SANTEE COMMUNITY CENTER
CIP 2018-31

ADDENDUM NO. 1

This Addendum No. 1 (132 pages in total) forms an essential part of the contract documents by revising the following:

5 S6.03 DETAIL 1 1/2" = 1'-0"

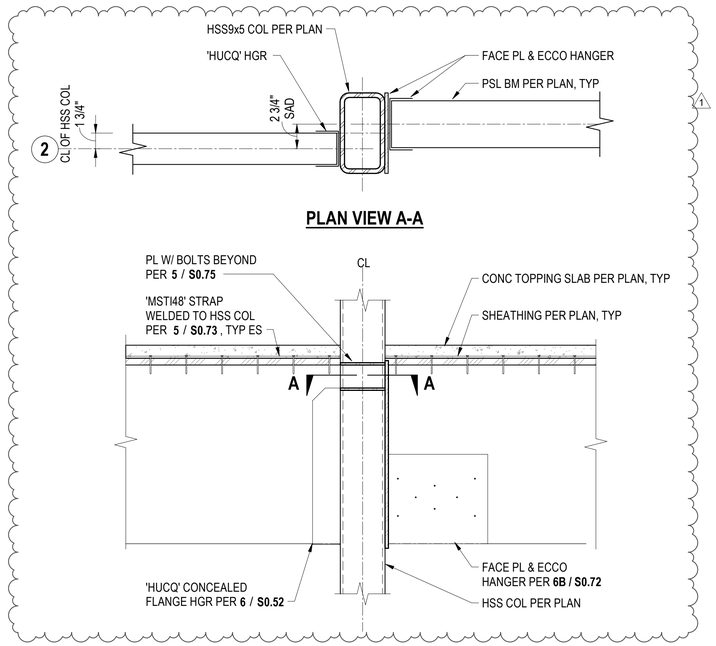
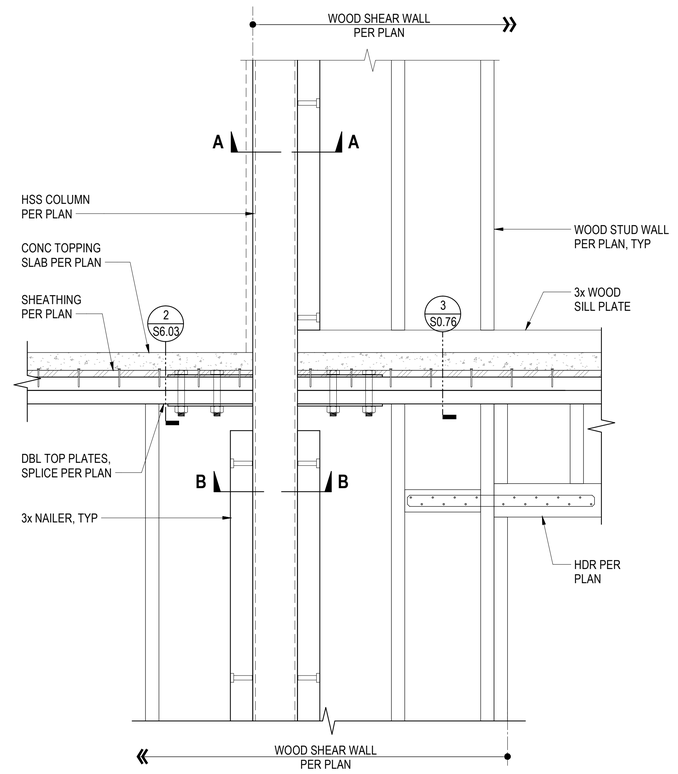
1C-50 Drawing Sheet **S6.03 DETAILS AND SECTIONS**

a. Revised details 3 and 4.
b. Added detail 5.
